MEMORANDUM FOR: J. C. Stepp, Chief, Geology and Seismology Branch, DSE

FROM: R. McMullen, Geologist, Geology Section, GSB, DSE
R. Jackson, Geologist, Geology Section, GSB, DSE

SUBJECT: VISIT TO NINE MILE POINT TO EXAMINE FAULT EXPOSED IN TEST PITS

FIGURE 1
 NINE MILE POINT
 RELATIVE POSITIONS
 OF FAULT, EXPLORATORY
 TRENCHES, & EXCAVATIONS

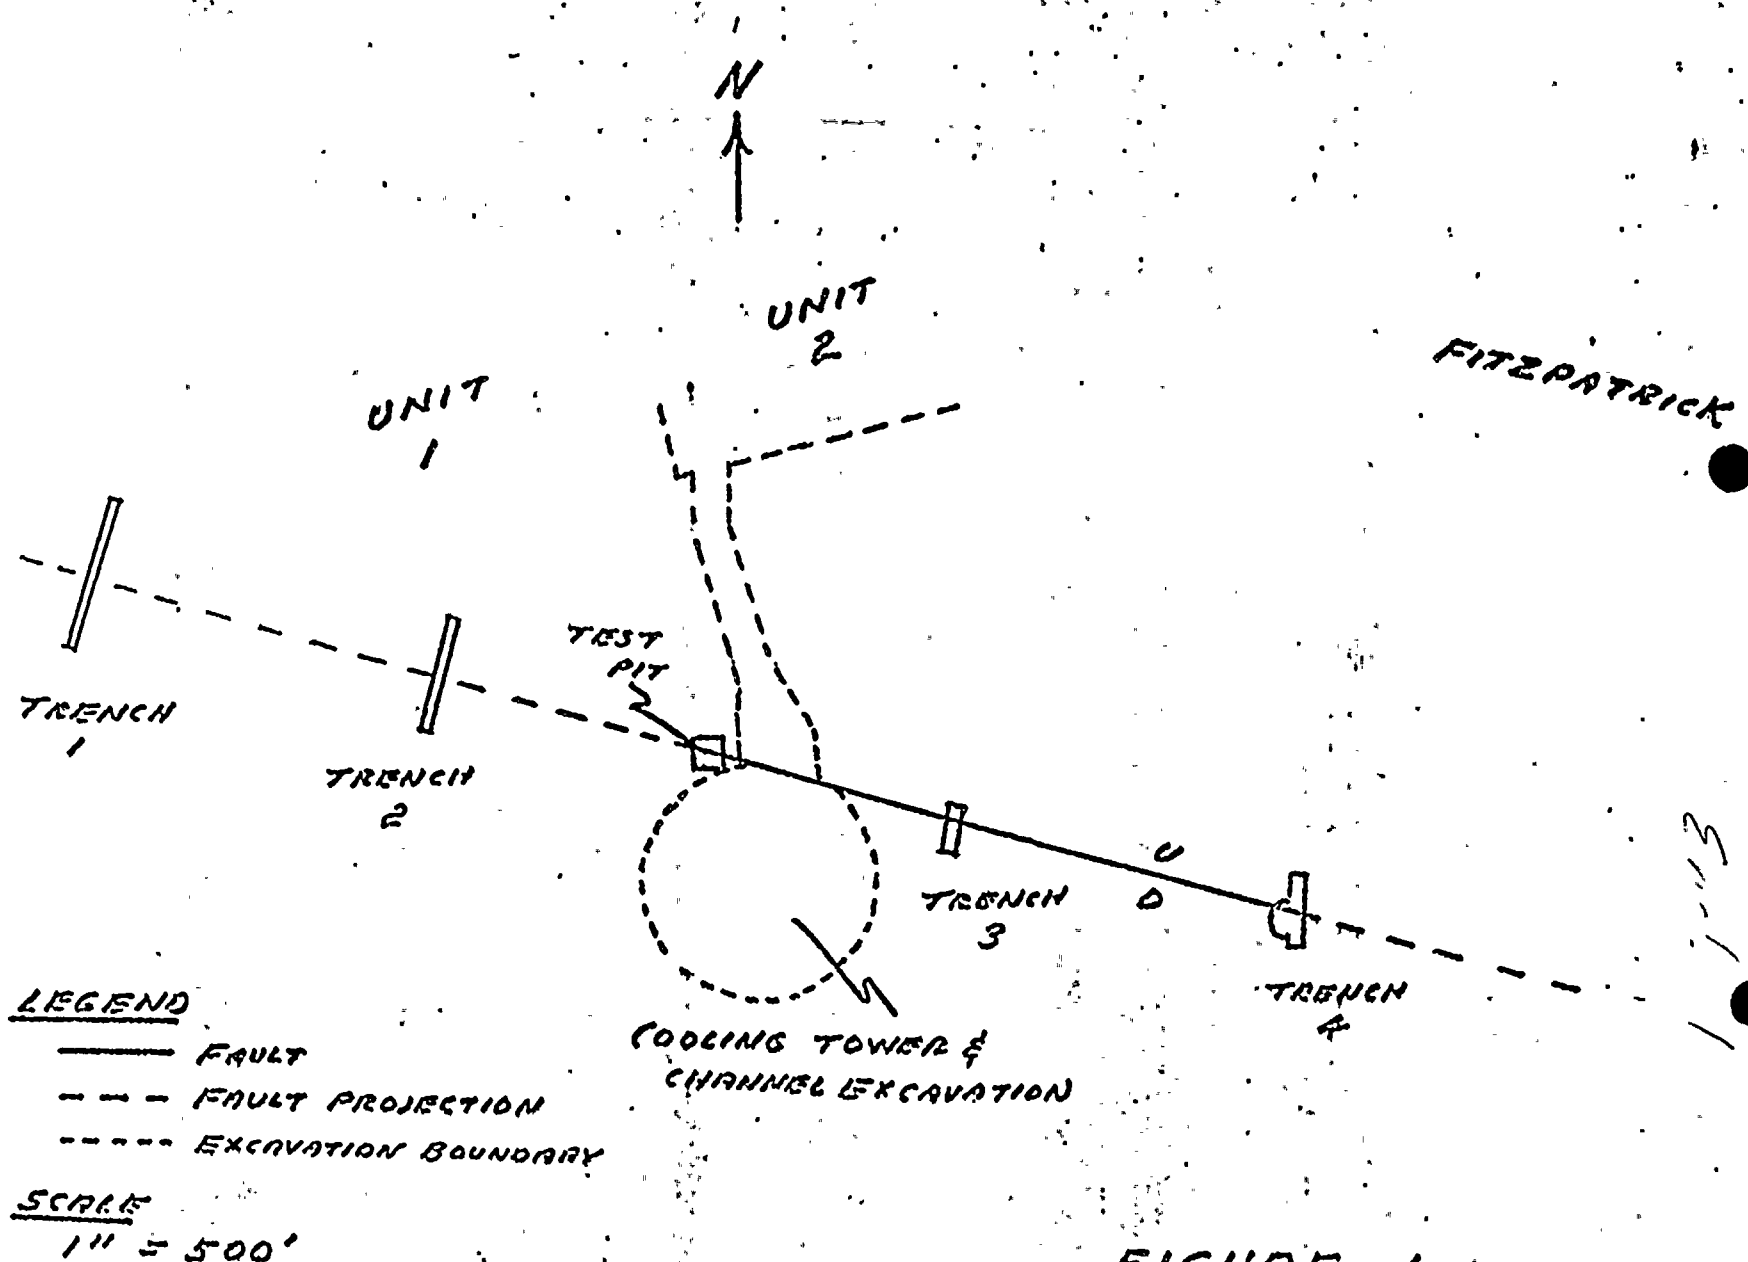
NRC geologists and a seismologist traveled to Nine Mile Point on December 22 to examine recently excavated test pits exposing other portions of the fault first reported to NRC by Niagara Mohawk on September 29, 1976. The purpose of the site visit was to follow up on a December 2, 1976 telephone conversation among representatives from Niagara Mohawk, its architectural engineer, Stone and Webster, its geotechnical consultant, Dames and Moore, and the Nuclear Regulatory Commission. During the phone conference, Niagara Mohawk reported on an exposure in an exploratory pit dug along the southeast projection of the fault (see memorandum of December 17 to J. Stepp from R. McMullen). Since excavation of the test pit described in the telephone memorandum Niagara Mohawk has excavated 2 additional exploratory trenches: the first along a southeast projection of the fault at the Niagara Mohawk property boundary; and the second along the northwest projection of the fault, approximately 800 feet northwest of the edge of the cooling tower trench. The former is designated as Trench #4 and the latter Trench #2. An exploratory pit was dug about 50 feet northwest of the cooling tower canal and is briefly described in the September 13 site visit memorandum to Stepp from McMullen. The excavation described in the December 17 memorandum has been designated as Trench #3. Trench #1 is located 1600 feet northwest of the north wall of the cooling tower canal. Enclosed is a figure showing the relative locations of the reactor units, fault, proposed cooling tower and canal, and the exploratory excavations.

As stated above, Trenches 1 and 2 were not available for examination, however, Trench #1 was examined during the site visit of November 4. There was no faulting apparent in Trench #1. Niagara Mohawk has stated, as a result of mapping Trench #2; that there is no faulting there either. Based on this information, the fault terminates somewhere between

the northwest edge of the canal and Trench #2. Niagara Mohawk plans to conduct investigations to determine the southeastern extent of the fault, the age of last movement along the fault, and whether that movement was tectonic or of glacial ice shove origin. The investigations will be carried out by Dames & Moore and Stone and Webster. A panel consisting of two geological experts has been assembled by Niagara Mohawk to review: (1) the data gathered thus far; (2) the proposed investigation program; and (3) later to review the results of that program. The panel members are Dr. D. Coates, SUNY Binghamton, and Dr. F. Donath, University of Illinois.

1. The fault does not pass beneath safety related structures. A northwest projection of the fault would pass several hundred feet south of Unit 1 at its closest approach;
2. The fault apparently dies out at some location between the Cooling Tower canal and Trench #2;
3. The region in which the site is located is relatively quiet seismically;
4. The vertical cut faces of the Nine Mile 2 excavation appear to be very stable and exhibit no evidence of high stresses in bedrock; and
5. Generally the bedrock in this region, with the exception of the subject fault, is relatively undeformed.

We required that Niagara Mohawk submit a letter report within two weeks summarizing the following:

1. The bases supporting its conclusion that the fault does not represent a hazard to the nuclear units nearby; and
2. The proposed investigation program
